REMARKS

Claims 1-19 remain pending in this application. Applicant is appreciative of the Examiner's well-reasoned and thorough analysis performed in the subject Office Action dated November 30, 2004. In view of the suggested revisions to the specification and responsive remarks presented herein, Applicant respectfully submits that each of the Examiner's objections have been alleviated, and respectfully requests immediate notice of allowance.

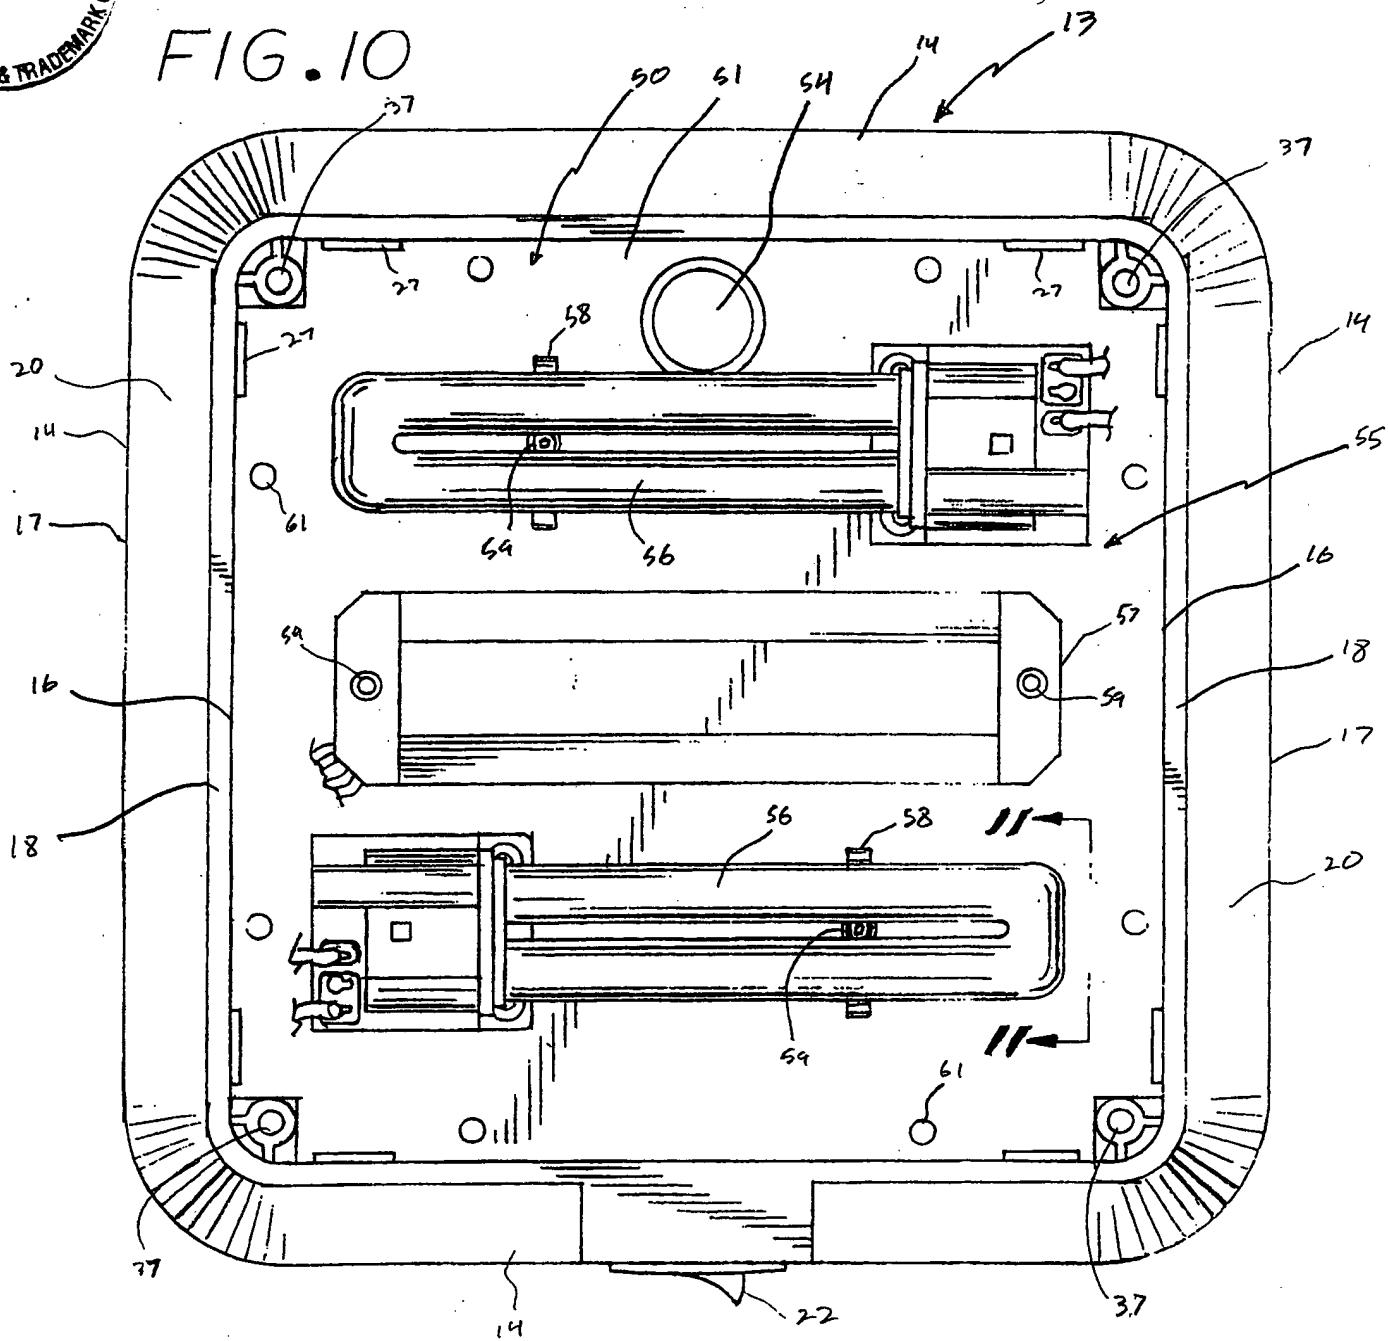
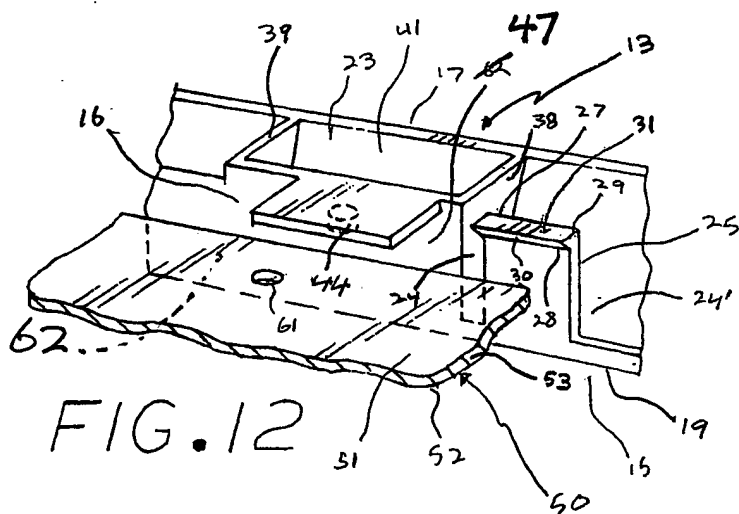
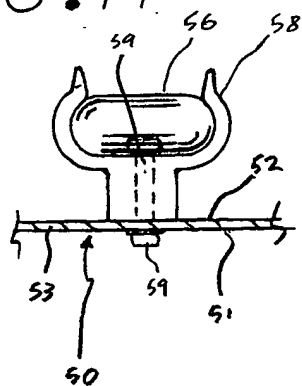
In the subject Office Action, the Examiner has also objected to the drawings. Specifically, the Examiner's detailed review of Applicant's drawings revealed that they failed to include reference element number 47, as referred to in the written description, and also failed to show a reference element number for certain features recited in the claims.

The attached replacement sheet of drawings (sheet 4 of 4 as originally filed) includes changes to Fig. 12. This sheet, which includes Figs. 10-12, replaces the original sheet including Figs. 10-12. In Fig. 12, previously mislabeled element 62 has been changed to element number 47, and a new depiction of element number 62 has been added.

In the formal drawings which Applicant has filed concurrently herewith, and in the Replacement Sheet and Annotated Sheet Showing Changes included as an exhibit to this document, Applicant has correctly depicted reference element number 47 in Figure 12 of Sheet 4 of 4. Also, reference element number 62 has been redrawn. Consideration of these revisions should remove this objection.
